From: davidgiacalone <dgiacalone@nycap.rr.com>
Subject: there is no below-ground exception to encroaching on the Park
Date: May 8, 2020 at 6:56:18 PM EDT
To: Suzanne Unger <suzanne.unger@gmail.com>
Cc: Haley Priebe <haleypriebe@gmail.com>, "Colleen B. Macaulay" <ladymac1129@aol.com>, Bob Lemmerman <robert1990@aol.com>, Douglas Chilton <djchilton27@gmail.com>

**North
Ferry St.
PUMP
STATION
PLANS**

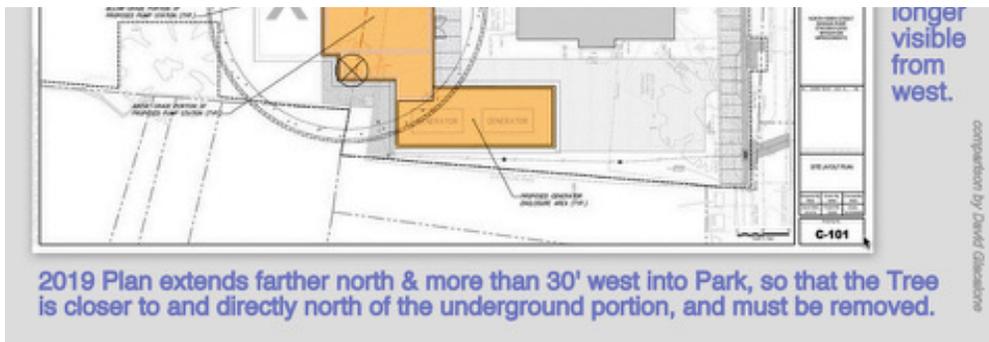
3. The 30-foot limit includes any buffer or landscaping - that is, parkland that will not have a building on it above ground.
4. The October 2017 Plan shows a concrete slab on the portion above the underground construction. That slab is visible, changes the parkland and is not usable as a park.

5. That concrete slab and the underground construction goes right up to the 30' line in the 2017 Plan. Anything past it is overflowing into the prohibited zone.

6. The analogous portion in the May 2019 Plan plat is significantly to the west of the 2017 Plan slab. The tree did not move. . (see 2nd and 3rd attachments)

Grand
Old Tree
is west
of the
underground
portion, and
preserved.

X = below-ground portion of pump station

"secret"
MAY
2019
Plan
